SERVICE LETTER

No. 534A

Availability of Engine Oil Quick Drain Valve

PA-28R-200 Cherokee Arrow

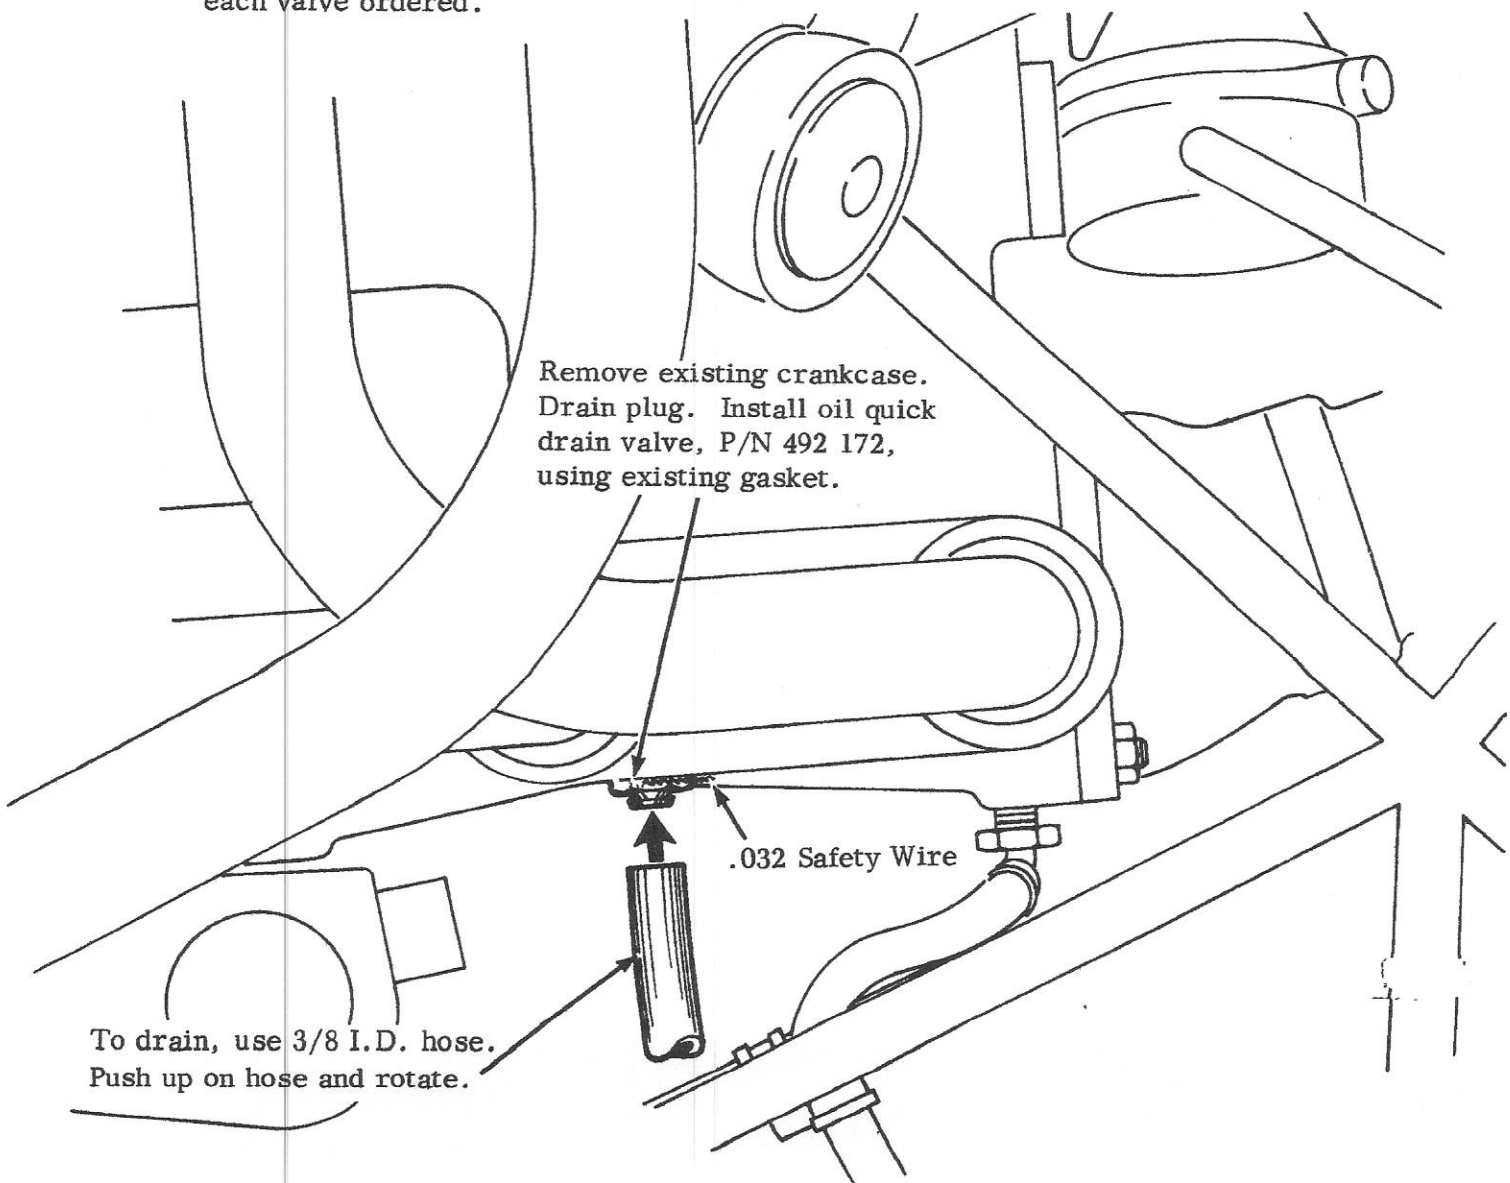
Remove existing crank case drain plug, and install new oil
quick drain valve assembly, part number 492 172V, as
indicated by the sketch on reverse side of this letter.

One (1) each Oil Quick Drain Valve, part number 492 172V;
being supplied to the field through Piper distributors on an
automatic factory distribution basis.
